TITLE: INVERTER POWER CABLE RUBBING

Prevost vehicles

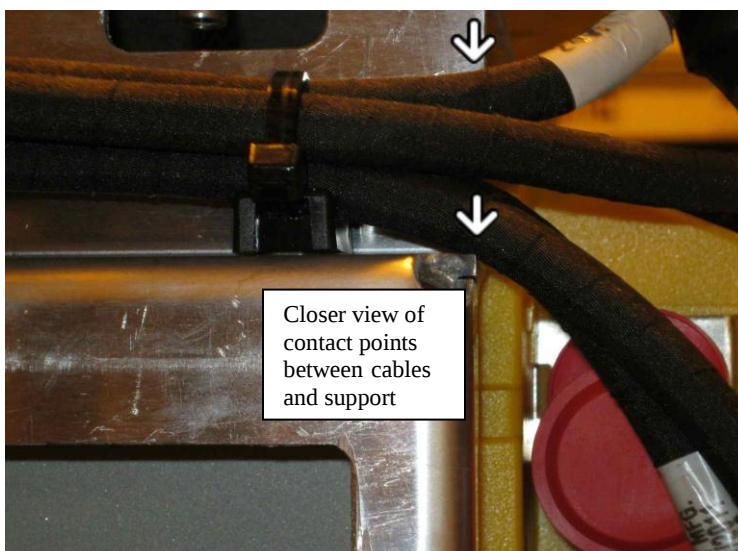
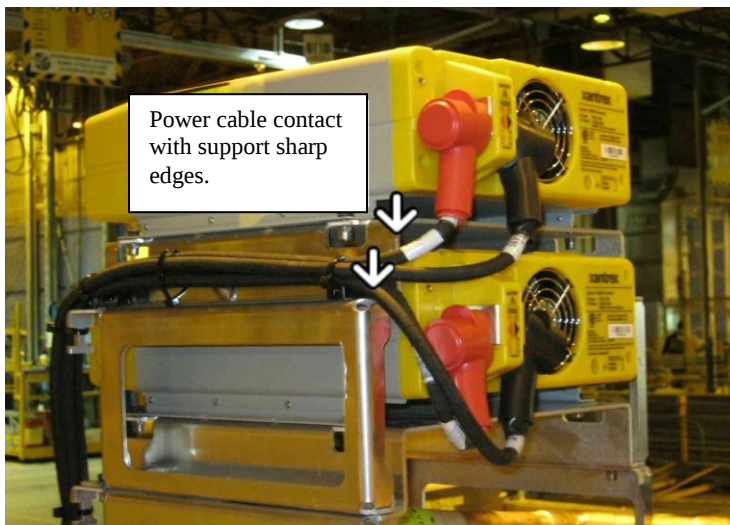
On the vehicles affected by this bulletin, a contact possibility exists between the power supply cable and the support sharp edge of the 24VDC/120VAC/1800 watts inverter (Part # 563082), leading to premature wear of the cable insulating tape. Follow the procedure described below to rectify the vehicle. / Sur les véhicules visés par ce bulletin, il existe une possibilité de contact entre le câble de puissance et l'arête vive du support de l'onduleur 24VDC/120VAC/1800 watts (Pièce # 563082) qui peut occasionner une usure prématurée de la gaine protectrice du câble. Suivre la procédure ci-dessous pour rectifier les véhicules.

- 1) To access the inverter and cables, open the mirror door located in the lavatory compartment at the rear of the vehicle.
- 2) Locate the three cables and the tie mount near the sharp edge of the inverter support (connection side of the inverter).

- 3) Cut the corresponding cable tie and move the 3 cables away from the support.
- 4) Position a new tie mount #504013 on the support in a way that the edge of the mount fits flush with the support edge. Mark the center of the mount on the support.
- 5) Using the mark on the support as a guide, drill a 5/32" hole through the support.
- 6) Install the new tie mount on the support using a #10 x 3/4" tapping screw #500957 in the 5/32" hole.
- 7) Cut a 1 9/16 inch (40mm) strip of single lip weather strip #509558 and securely install it on the vertical edge of the support next to the newly installed tie mount.

- 8) To finish the installation, reinstall the cables in both tie mounts parallel to the support and secure them using one 21 inch (358mm) cable tie #504637 in the original tie mount.
